Subject: Applicant's Response to Data Requests, Set 2A (#155-172)
Rio Mesa Solar Electric Generating Facility (11-AFC-04)

Applicant's Response to Data Requests, Set 2A (Nos. 155-172)

Rio Mesa Solar Electric Generating Facility (Rio Mesa SEGF)

(11-AFC-04)

KIT FOX BURROWS OBSERVED DURING BIOLOGICAL SURVEYS OF THE RIO MESA SOLAR ELECTRIC GENERATING FACILITY

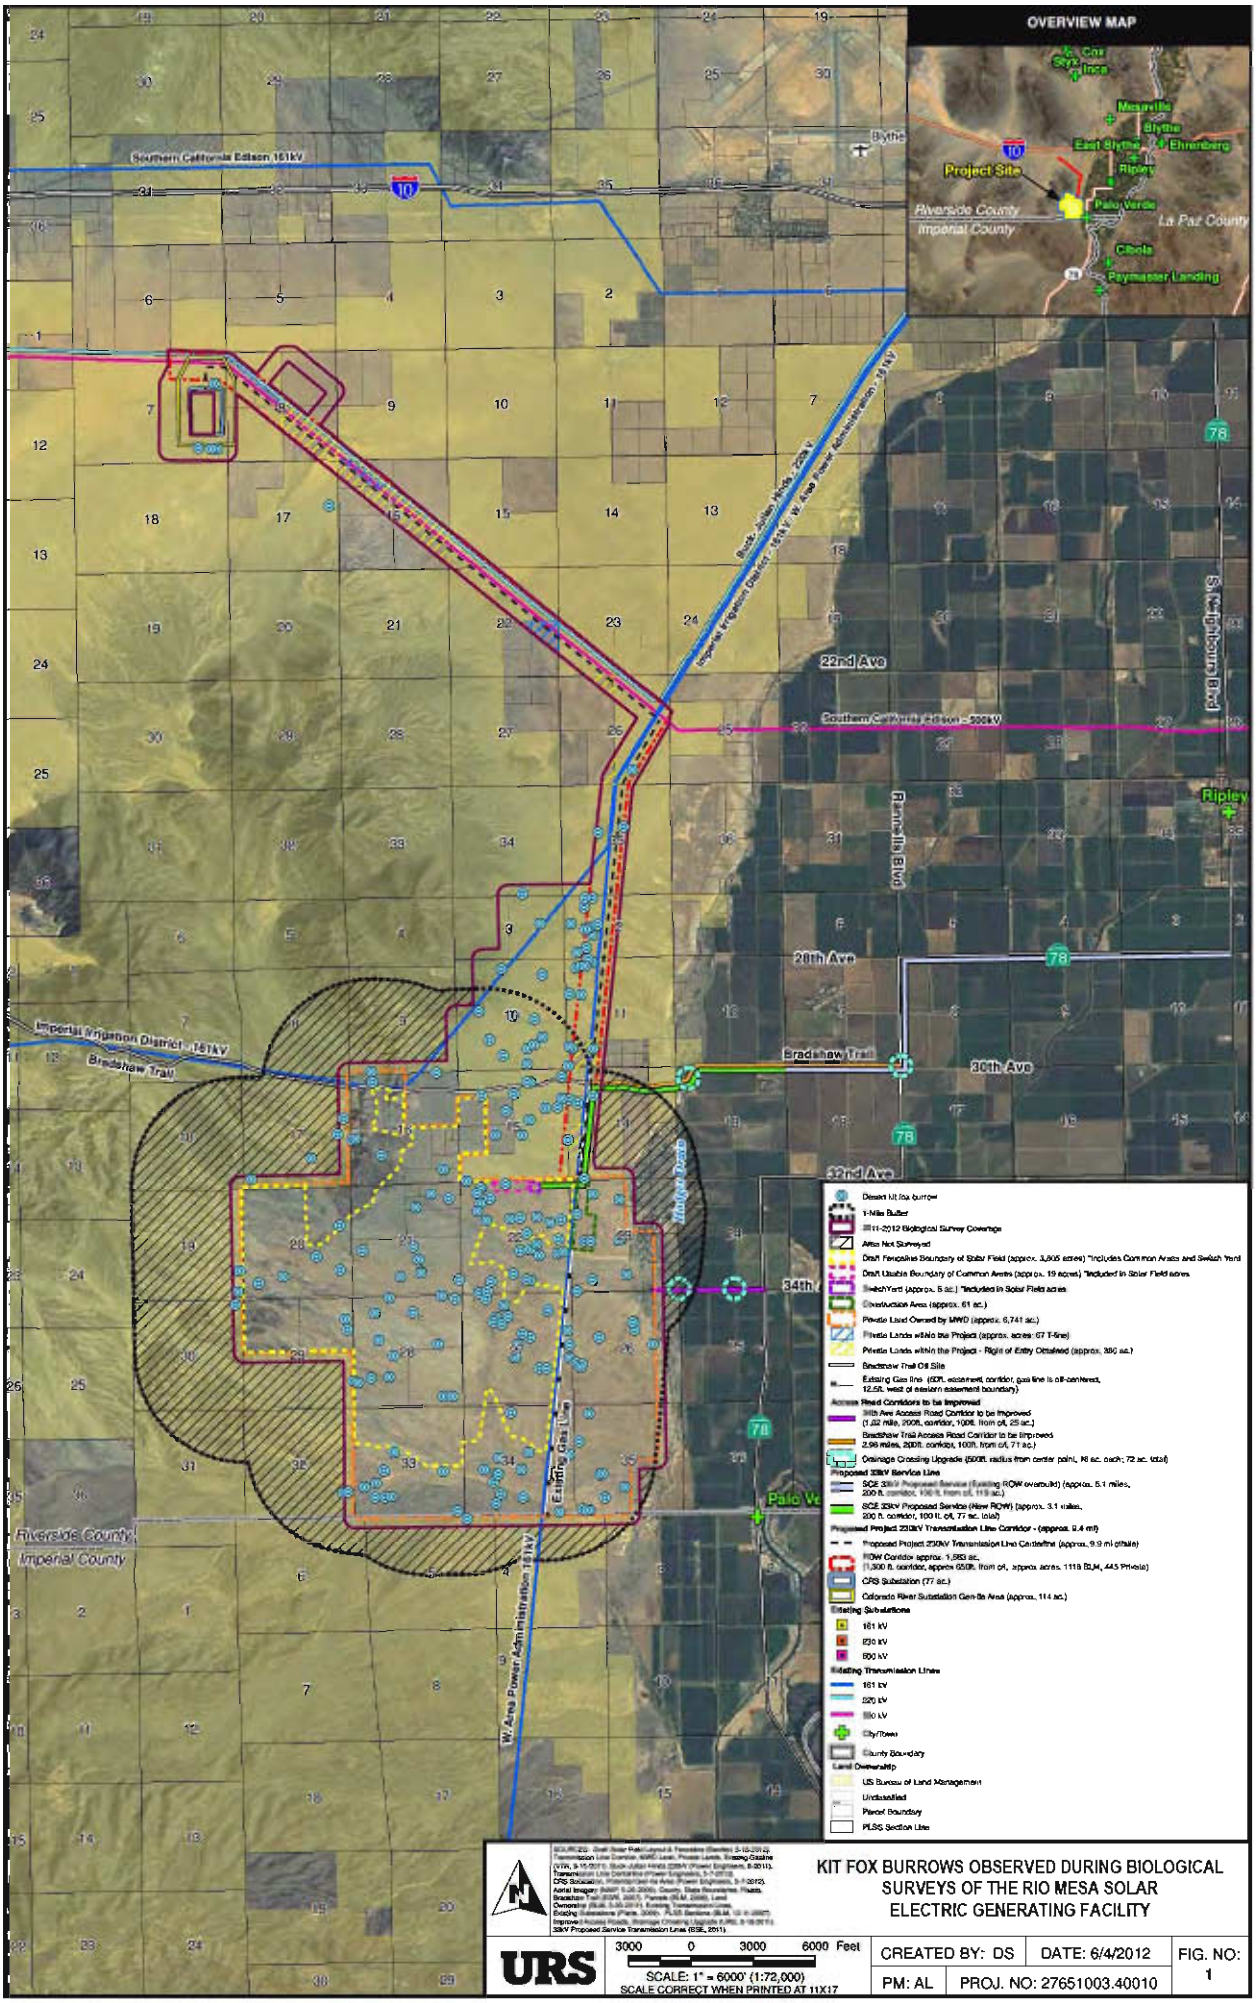
155. Please provide a Draft Desert Kit Fox Management Plan, to completely describe all methods that may be used for desert kit fox passive relocation, including:

a. A pre-construction survey and clearance field protocol, to determine:

i. The number and locations of single or paired kit foxes on the project site that would need to be passively relocated; and
ii. The number and locations of desert kit fox burrows or burrow complexes that would need to be collapsed to prevent reoccupancy by the animals;

An extensive kit fox burrow survey and mapping effort was conducted at the Rio Mesa Solar site in 2011. All kit fox burrows within the 2011 project assessment area and within a 500-foot buffer were mapped and their status documented. These burrows are shown in Figure 1. During the 2011 surveys, 193 desert kit fox burrows or burrow complexes were observed within the original Biological Study Area (BSA), of which 67 are within the current proposed fenced development area. Because numerous burrows occur within the home range of each single female, not all burrows are active at the same time; only 15 of the detected burrows appeared to be active or potentially active based on the presence of fresh tracks and/or scat.

CDFG-approved biologists will conduct preconstruction surveys to verify kit fox burrow locations in the proposed fenced development area between 14 and 30 days before initiation of ground disturbance. The kit fox preconstruction survey will be part of the desert tortoise and burrowing owl preconstruction surveys already planned for the fenced development area, and evaluation of the documented kit fox burrows will be included in these preconstruction surveys.

KIT FOX BURROWS IN RELATION TO THE PROPOSED FENCED DEVELOPMENT AREA OF THE RIO MESA SOLAR ELECTRIC GENERATING FACILITY

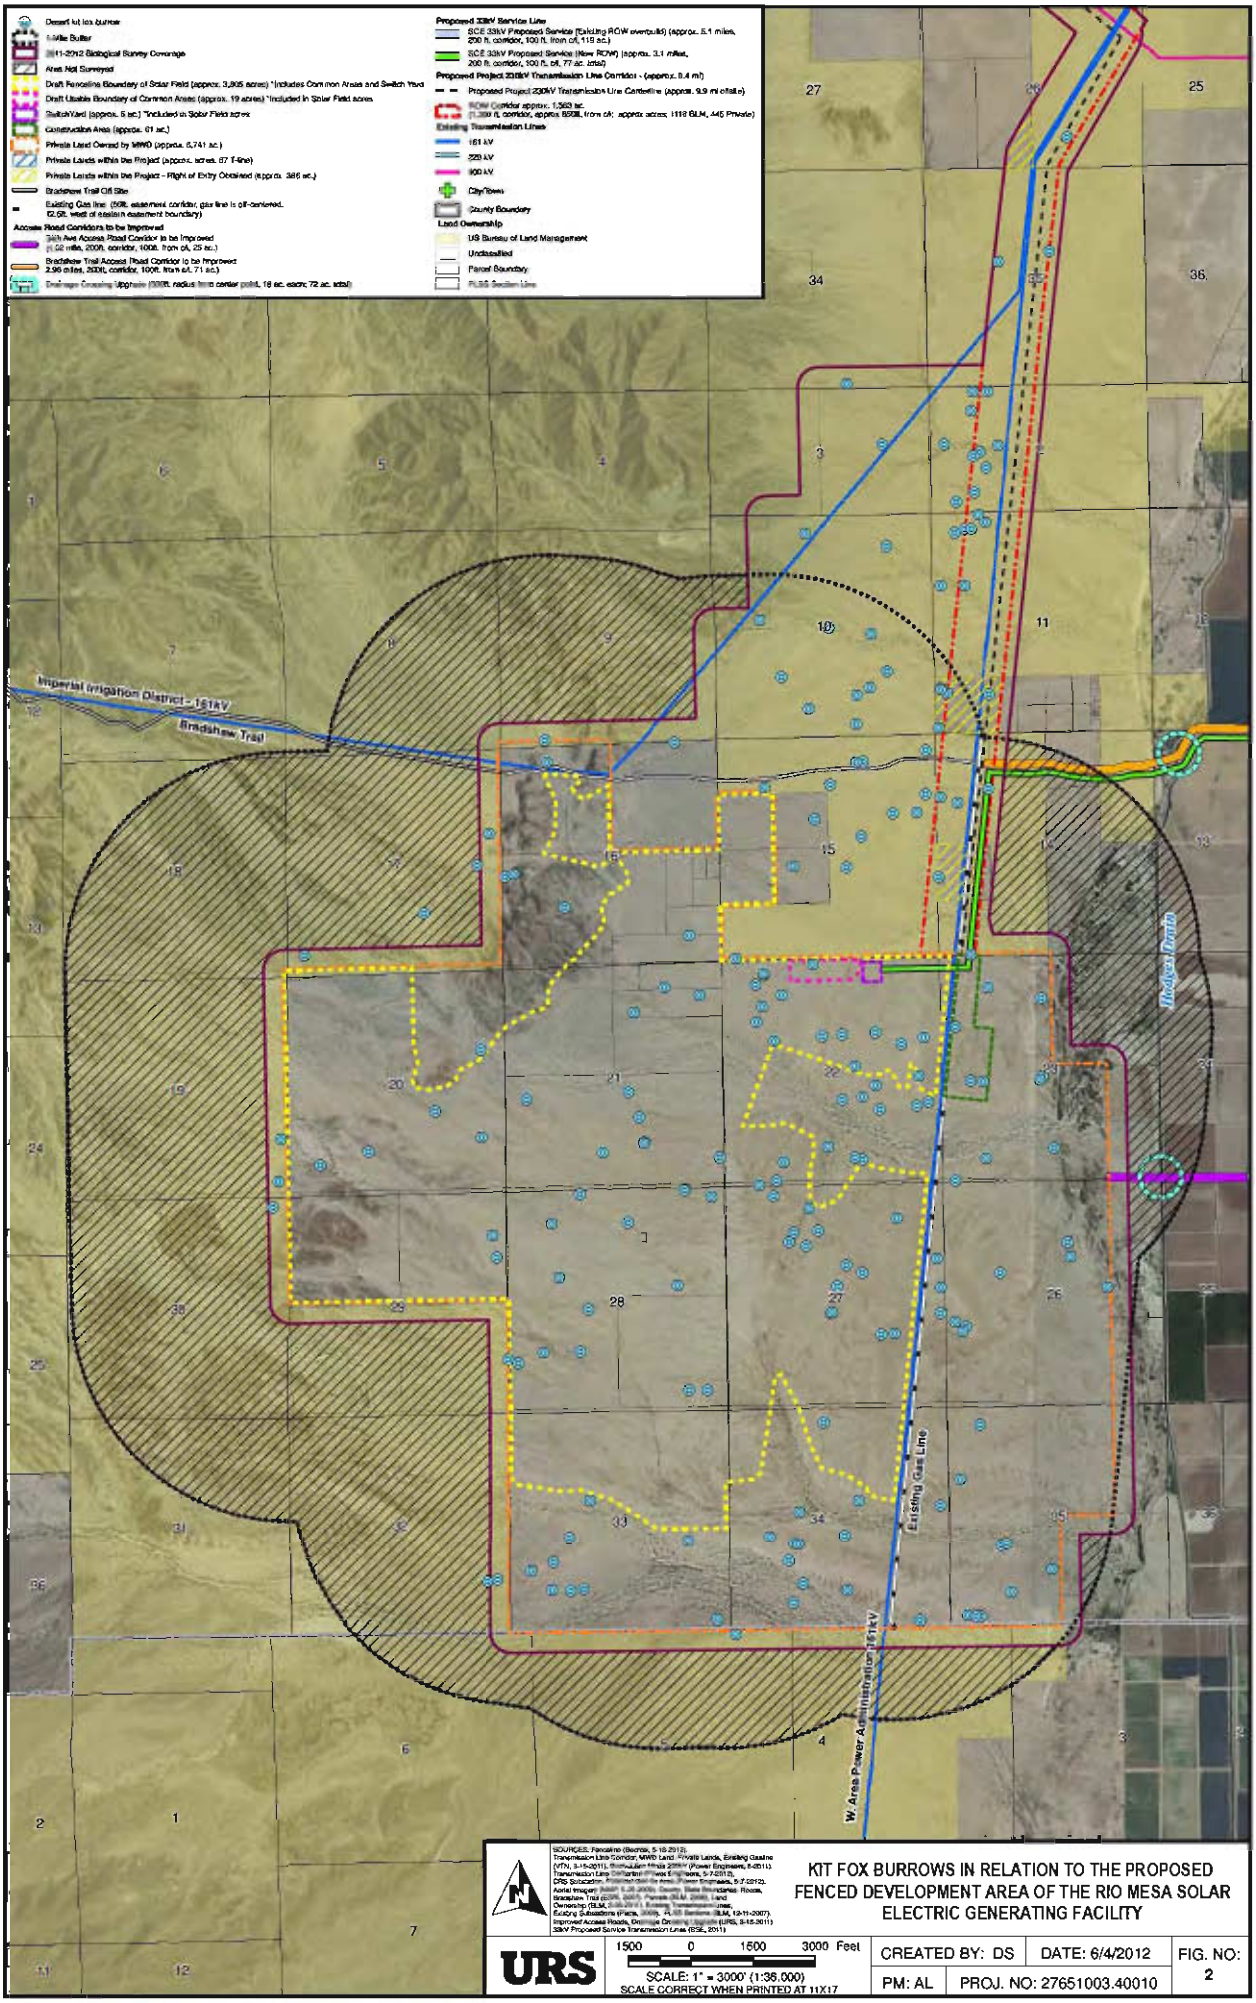
d. Proposed scheduling of the passive relocation effort;
e. Methods to minimize likelihood that the animals will return to the project site;
f. Descriptions of any proposed or potential ground disturbing activities related to kit fox relocation (e.g., artificial burrow construction);

After all burrows within the proposed development area are collapsed, fencing will be erected around the perimeter of the development area (see Figure 2). This fencing is intended to prevent desert tortoise and kit fox from returning to the development area. Biologists will monitor the proposed development area periodically between completion of burrow destruction and completion of fencing installation to ensure that foxes do not return to the development area.

CDFG POTENTIAL WATERS OF THE STATE
DATA RESPONSE 162
RIO MESA SOLAR
ELECTRIC GENERATING FACILITY

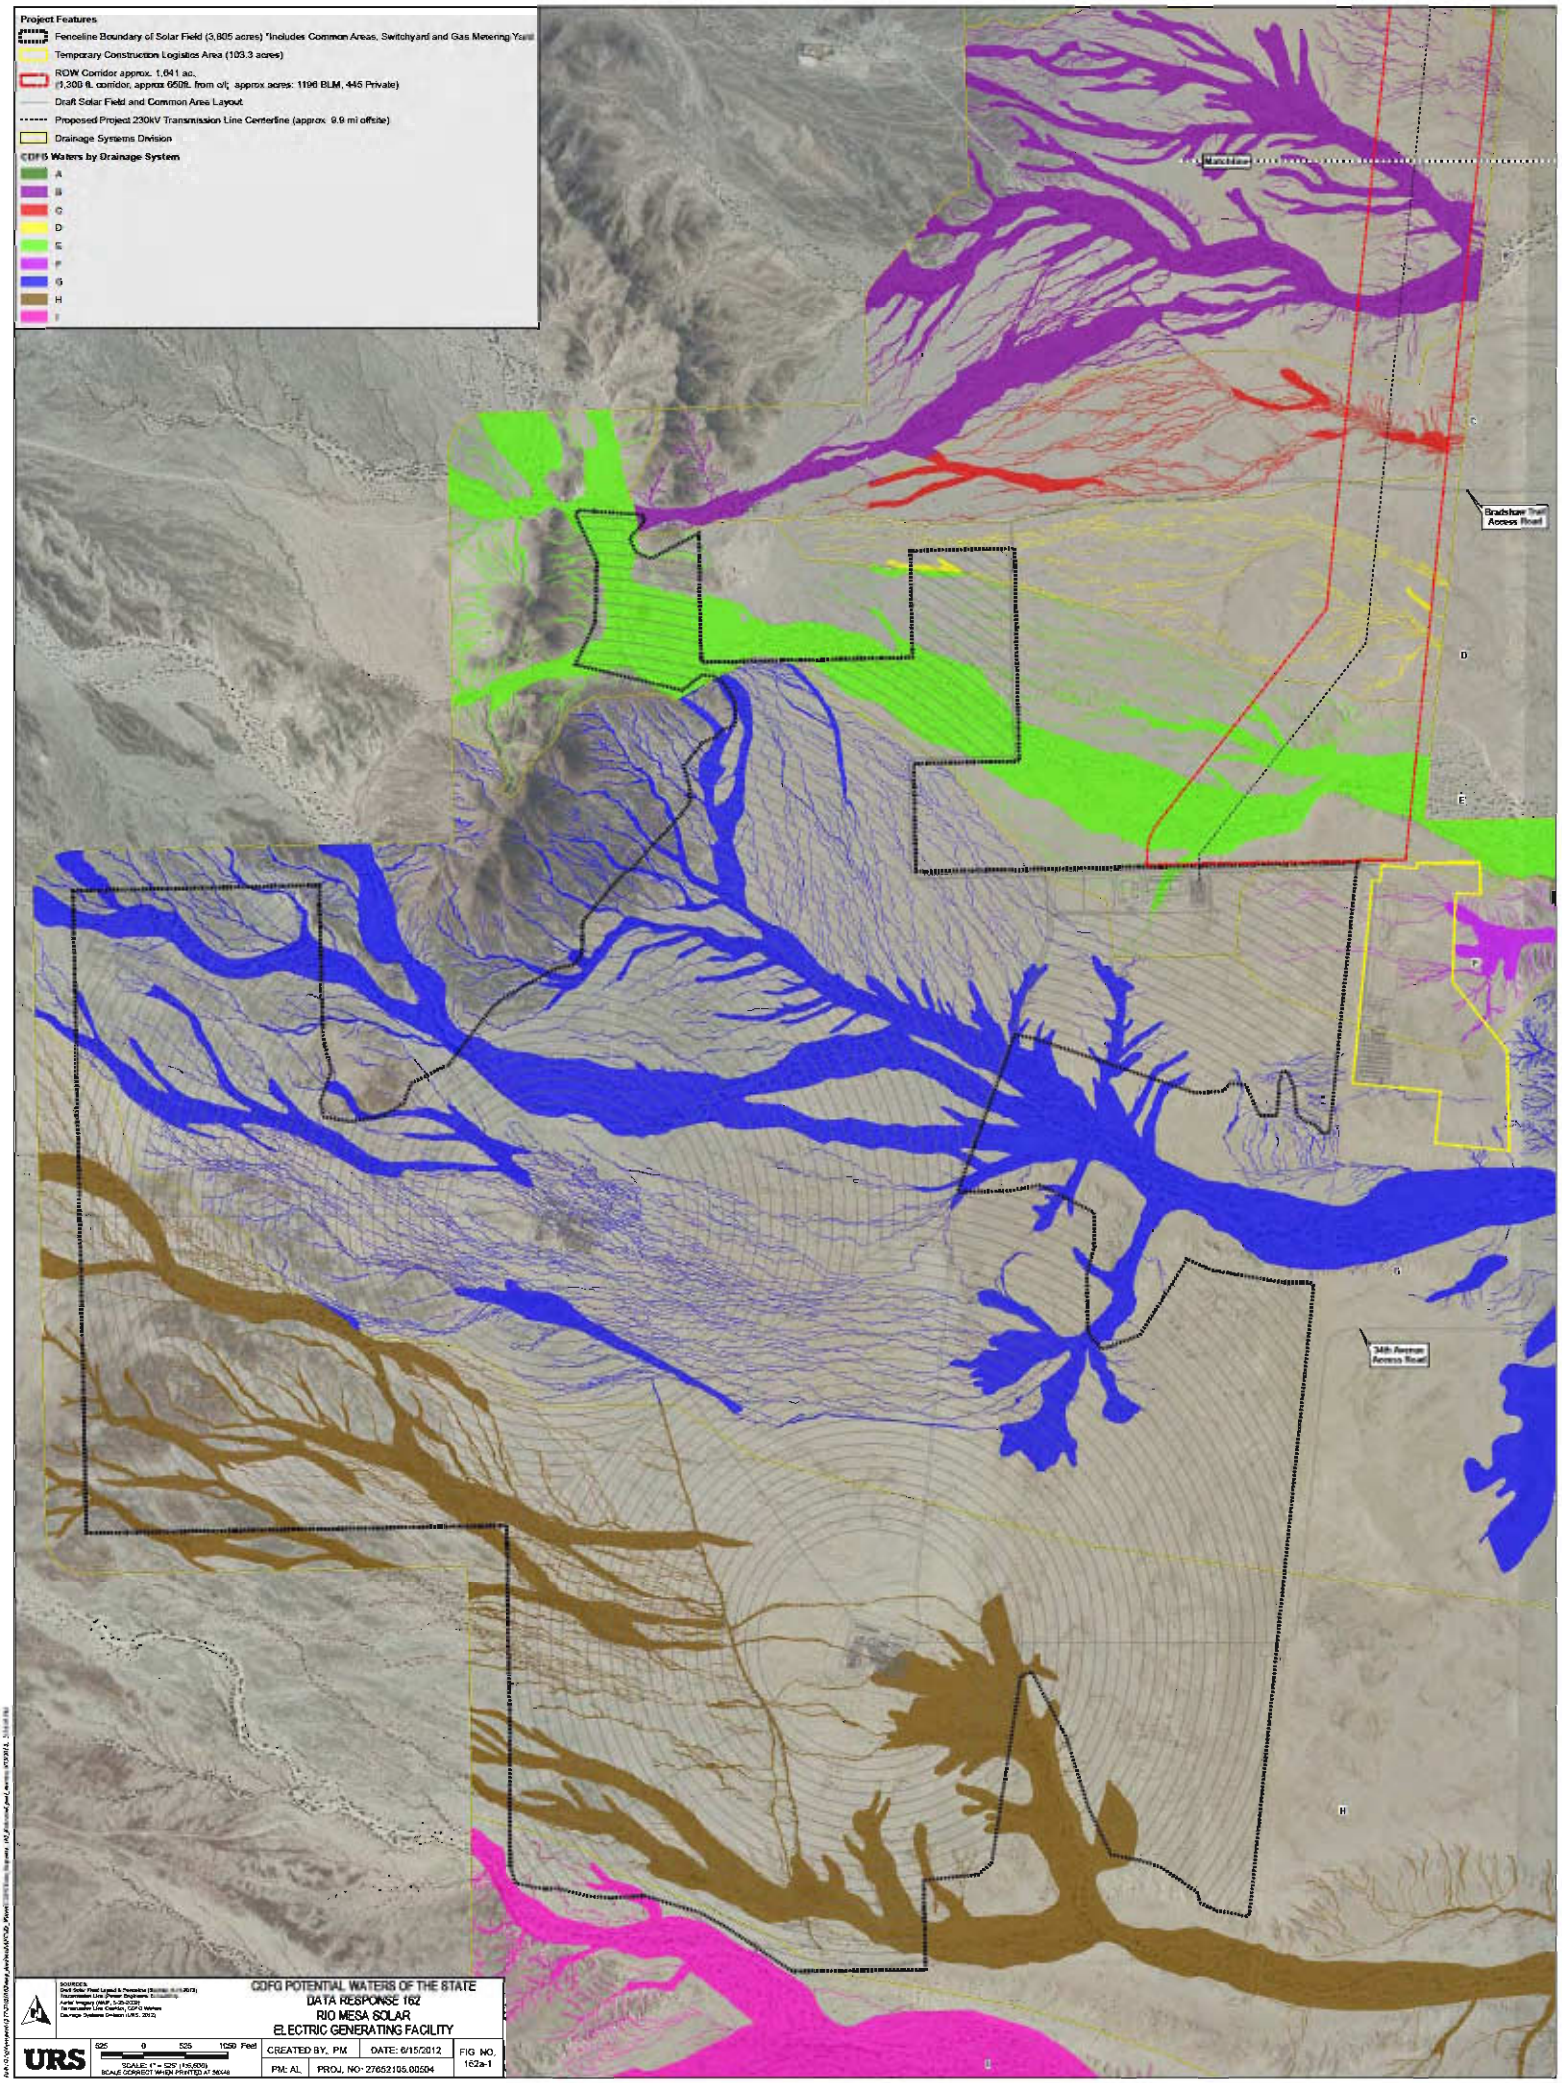
162. In a 1:3,600 or finer scale map, please show:

a. The project footprint and outline of any project related disturbance areas; and
b. Numerical values of elevation contour lines and widths of jurisdictional features.

162a: Two e-sized plots (Attachment 162a-1 covering the main project site and Attachment 162a-2 covering the transmission line corridor) of the project footprint and outline of any project related disturbance areas.

162b: Two e-sized plots (Attachment 162b-1 covering the main project site and Attachment 162b-2 covering the transmission line corridor) of the numerical values of elevation contour lines and widths of jurisdictional features.
